Save Long Beach Island, Inc.  
P.O. Box 2087, Long Beach Township, NJ 08008  
[www.SaveLBI.org](http://www.SaveLBI.org)

July 31, 2024

Regarding: EPA Permit Number OCS-EPA-R2 NJ 02.

Please see and consider the comments below from the Save Long Beach Island organization on the proposed Clean Air Act Outer Continental Shelf (OCS) air permit for the Atlantic Shores South offshore wind project.

**Figure 1**

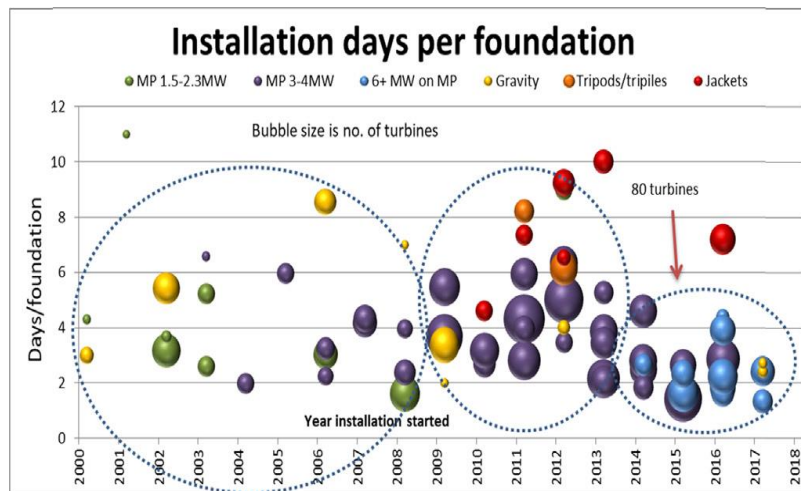
As shown, the installation time for smaller 6-megawatt (MW) turbines on monopile foundations has leveled out at one every two days. It can only take longer for the larger diameter foundations here for the 15 MW turbine foundations here.

For those foundations, the two days per foundation is low because the steel surface area being driven into the seabed increases significantly for the larger turbines foundations here as opposed to the 6 MW turbines shown above.

approximately 12.3 ft.<sup>2</sup> as opposed to 3.6 ft.<sup>2</sup> for the 6 MW turbine, or 3.5 times as much. This is the area offering resistance to the pile driver. It is therefore reasonable to assume that it will take about three times as long to pile drive one of the 15 meter diameter foundations, as opposed to the 7.5 to 8 meter diameter foundations in the chart above.
